Addendum No. 1

**RE: Planter's Pointe Lift Station
Thompson Engineering Project No. 22-1101-0257**

The plans and specifications for the above referenced project are hereby revised as follows:

DATE: APRIL 2023
JOB NO.: 21-1101-0257
DRAWING NO.: C604
REVISION NO.: B

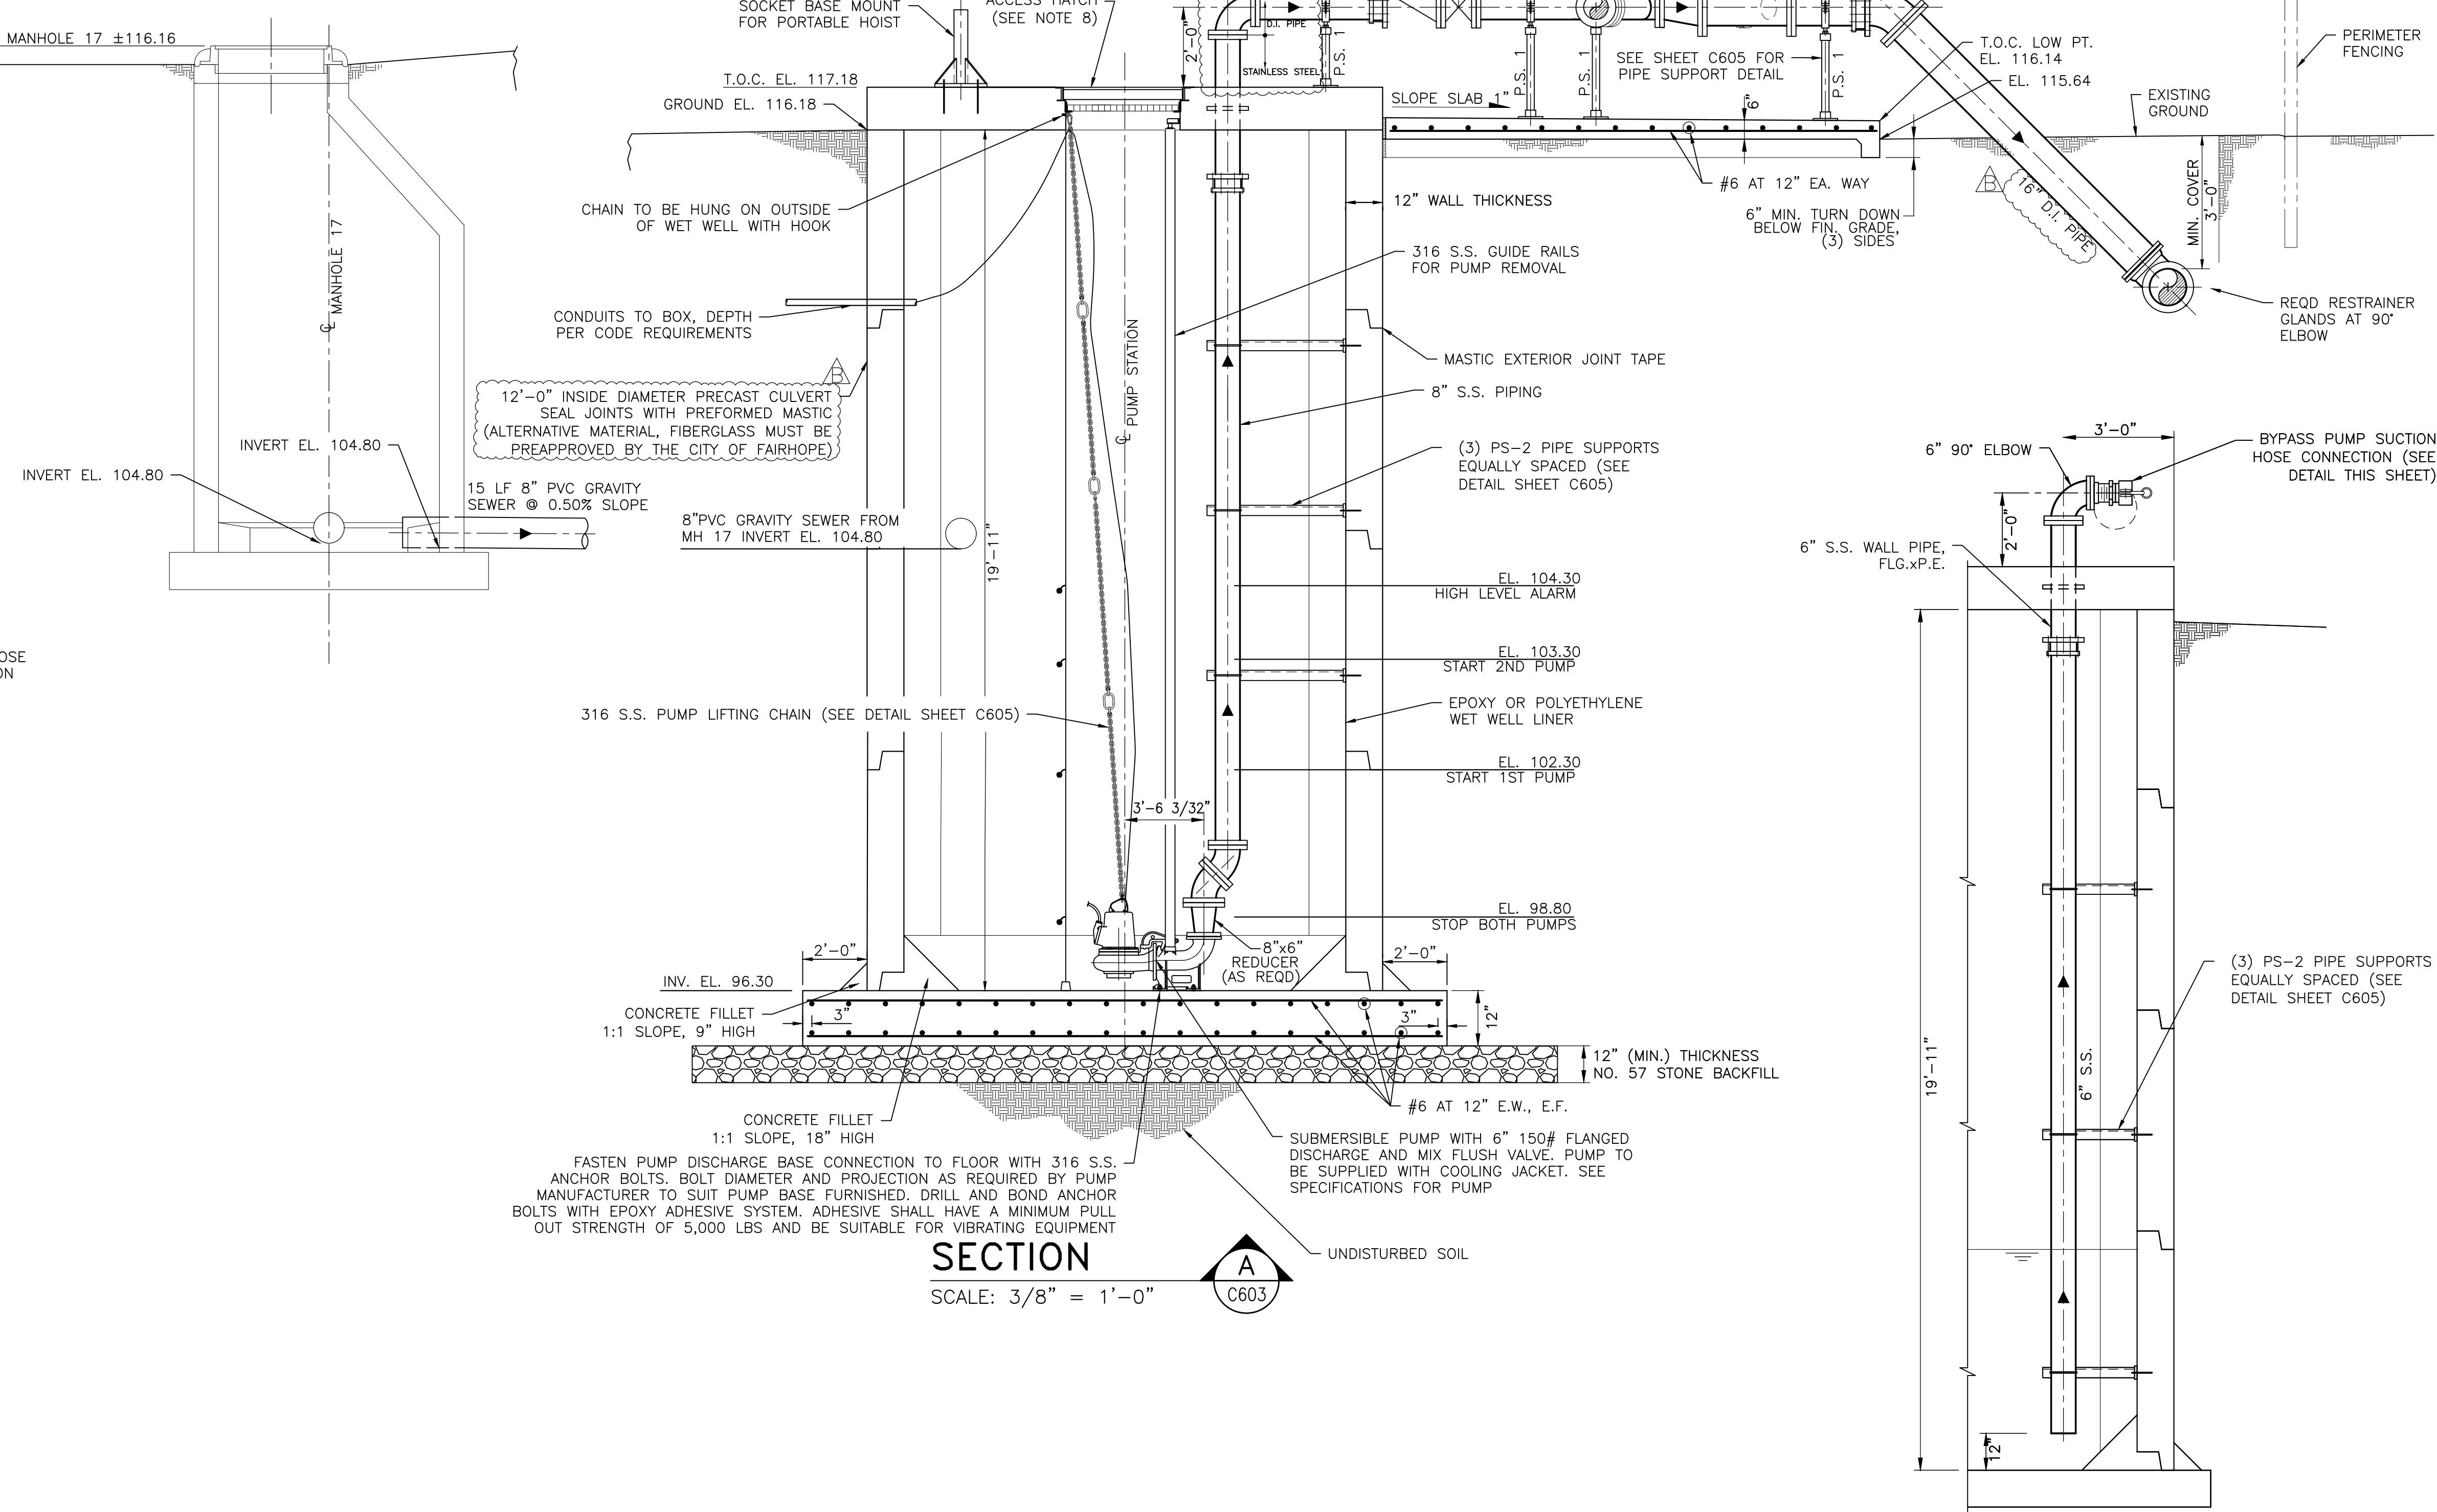
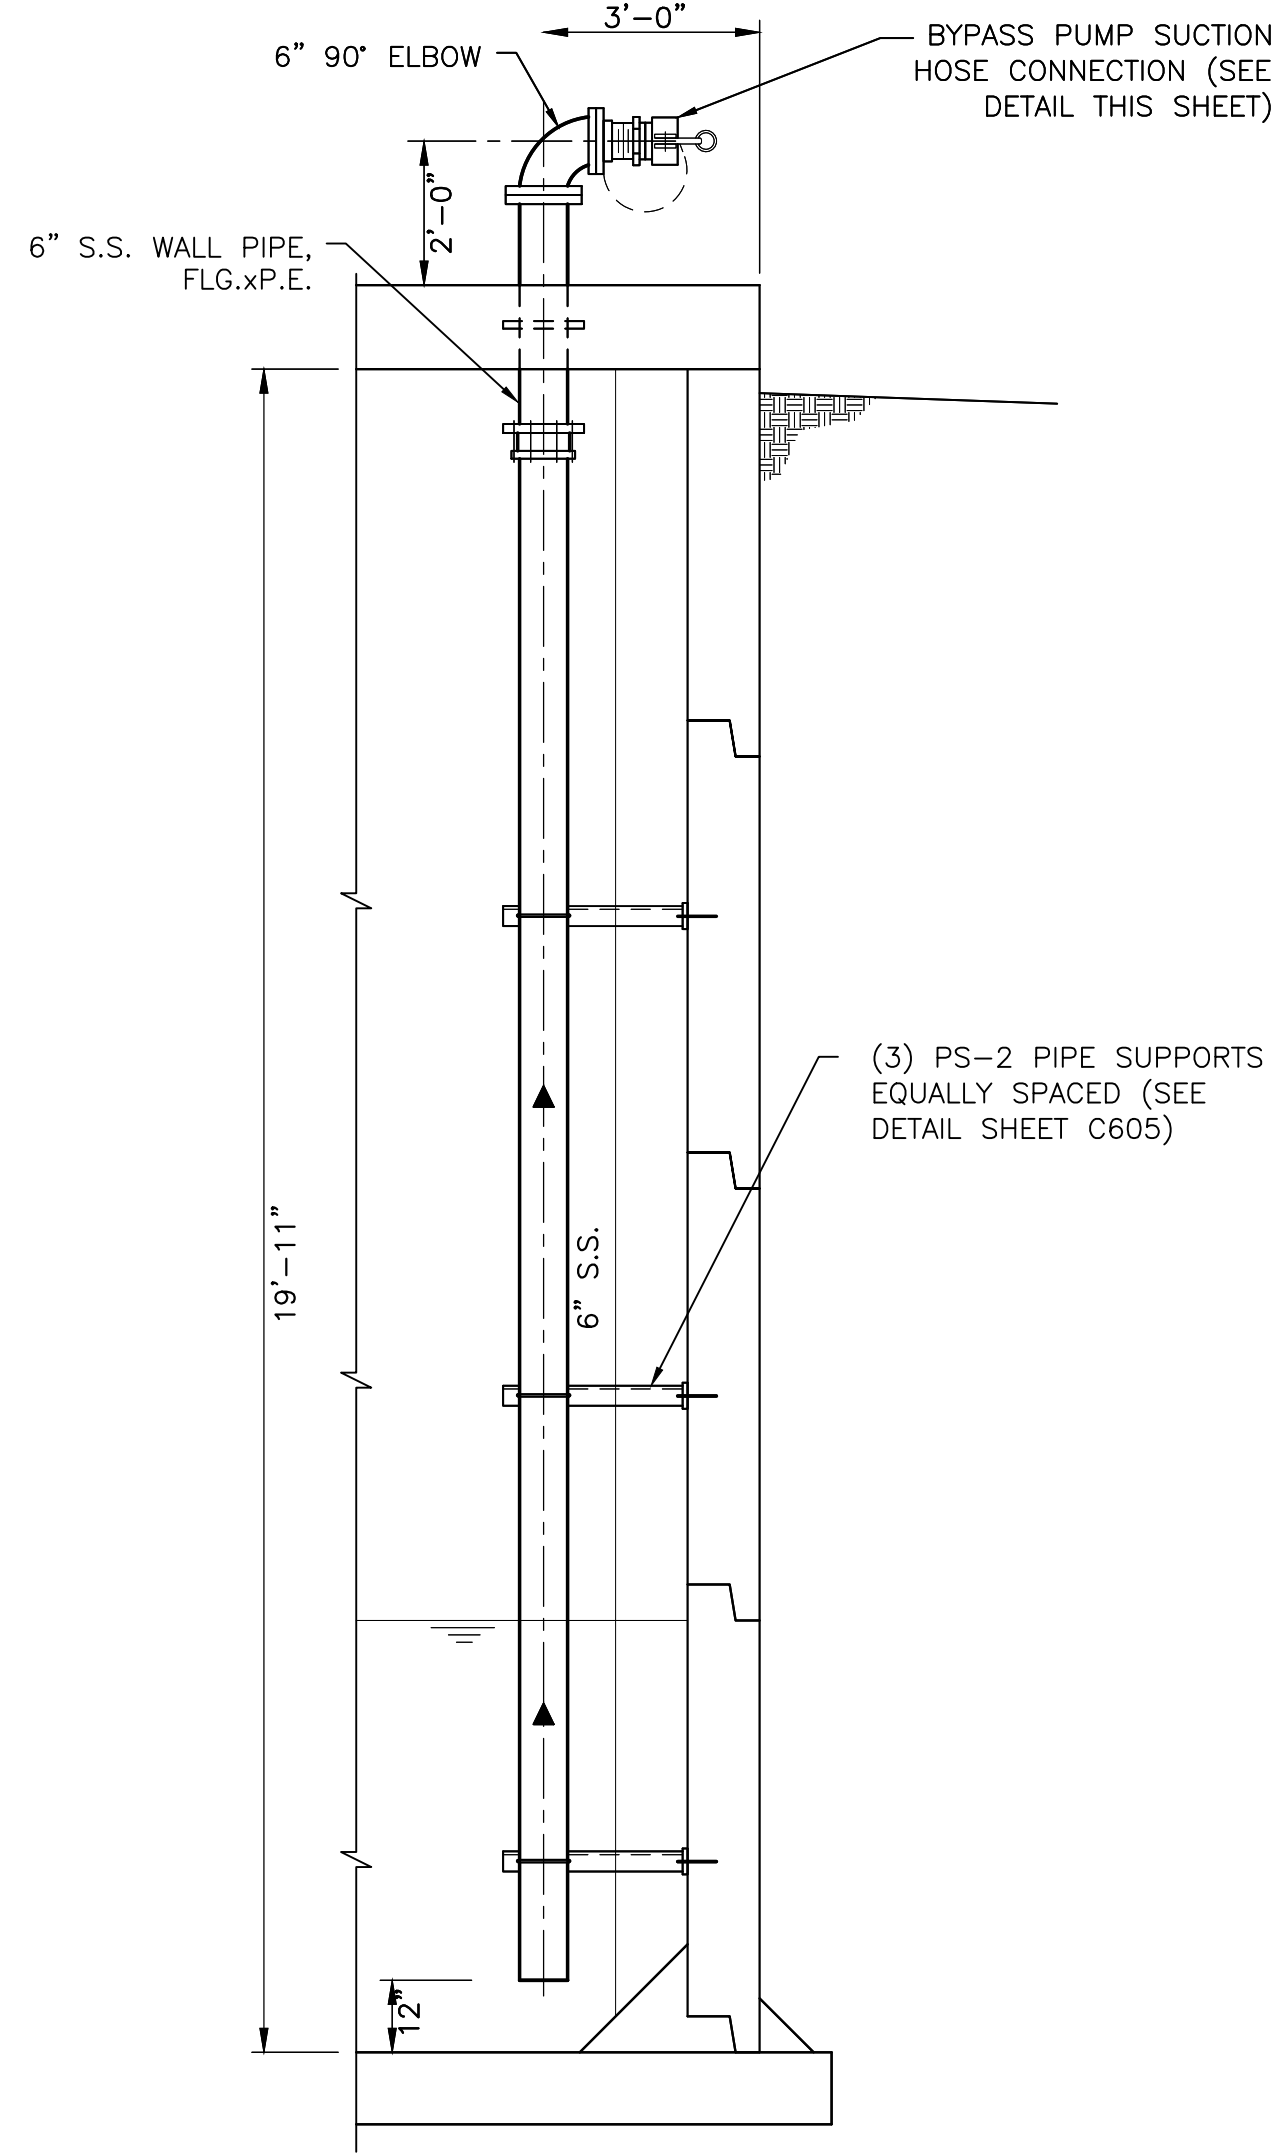
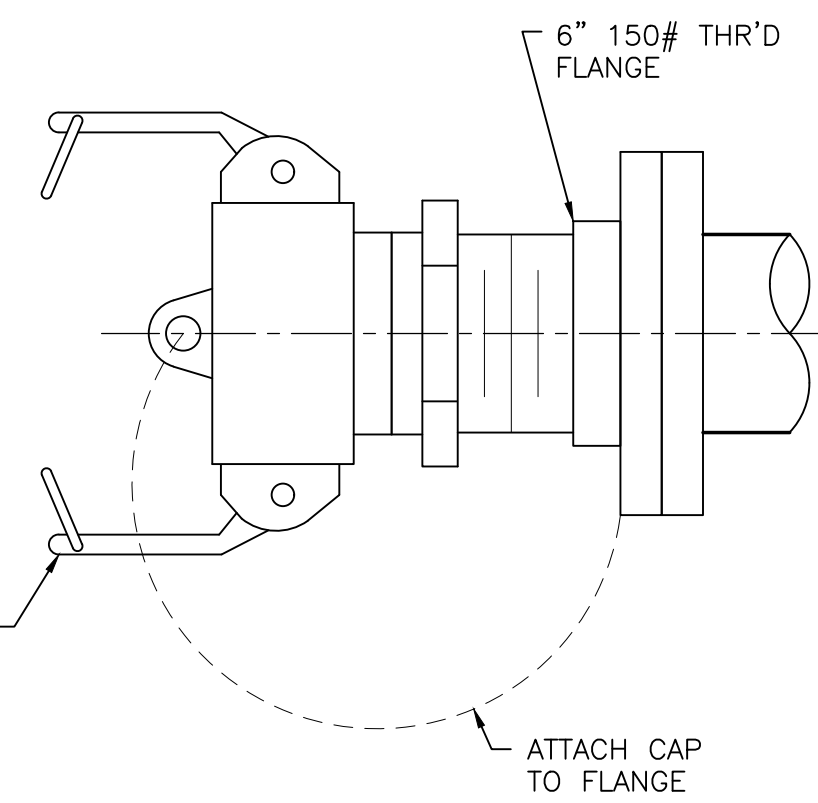
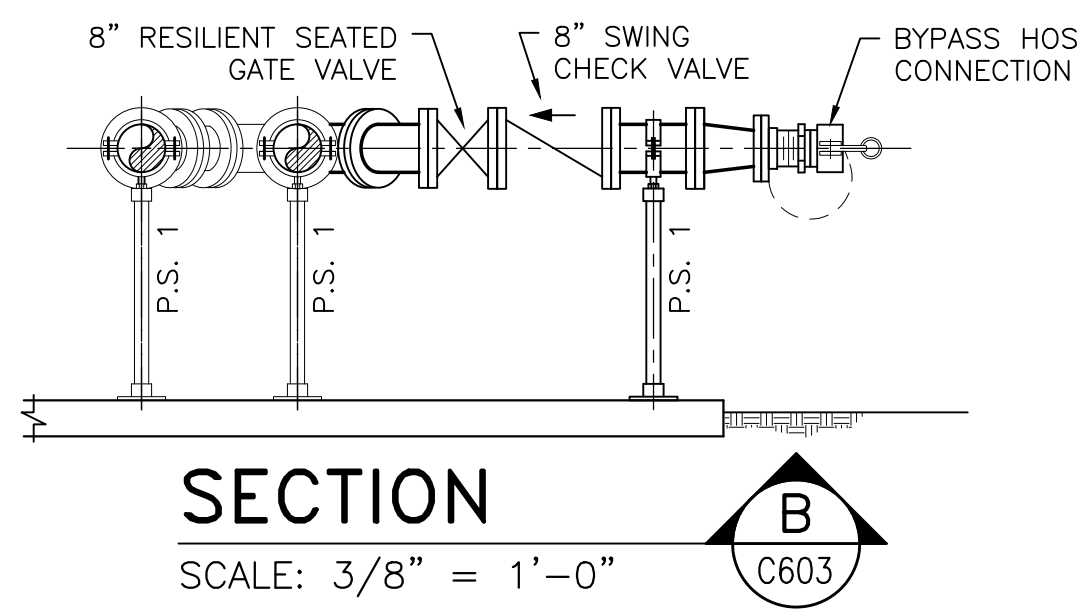
- Sheet C604 has been revised from 16" HDPE pipe to 16" D.I. pipe.
- Sheet C604 call out has been revised to 12'-0" inside diameter precast culvert seal joints with preformed mastic (alternative material, fiberglass must be preapproved by the City of Fairhope.
- Sheet C606 concrete structure notes have been revised to include ¾" White Epoxy Coated Plywood Walls and Ceiling.
- Sheet C606 wet well note has been added "Fiberglass can be used as an alternative. The applicable design standards are the plans, City of Fairhope Standard Specifications for Constructing Sanitary Sewer Facilities and Water Facilities, ASTM D3753, Fiberglass manufacturer's recommendations".

9. Why is the 16" HDPE pipe coming out of the ground?
 - Answer – The 16" HDPE pipe is underground. The 16" pipe coming out of the ground is ductile iron pipe.
